9 May 2017  
WTJ17-87

**Section 96(1A) Modification Application (SSD 7917) – MOD 1**

**Horsley Drive Business Park, Lot 3, Burilda Close, Wetherill Park (Lot 5 DP 1212087)**

**Figure 2: Proposed Site Plan**

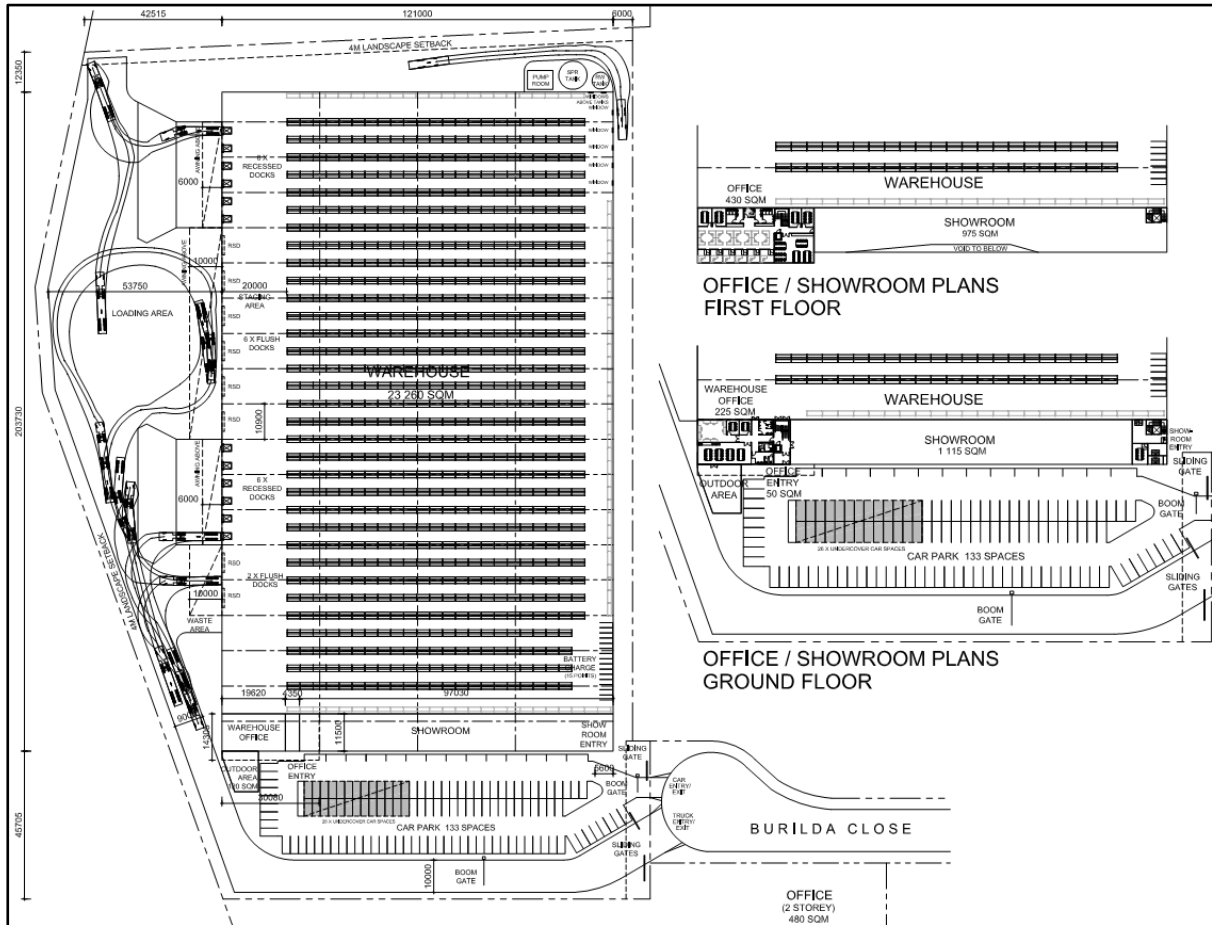
- Amalgamate the two (2) approved tenancies into one (1) warehouse/distribution facility.
- Align the warehouse office, showroom and office including a minor increase in height from 10m to 11.5m.
- Increase the Gross Floor Area (GFA) of the warehouse by +2,600m<sup>2</sup>.
- Relocate office and office entry to the west end of the building.
- Relocate undercover parking spaces to the west end of the car park.
- Addition of a meeting room and secure lobby to the showroom entry on the ground floor.
- Addition of a void at the first floor to allow occupants to look down to the ground floor below.
- Relocation of outdoor area.
- New direct access from main office to showroom and warehouse office.
- Glazing from main office into warehouse from the open work areas, meeting rooms and circulation stair.
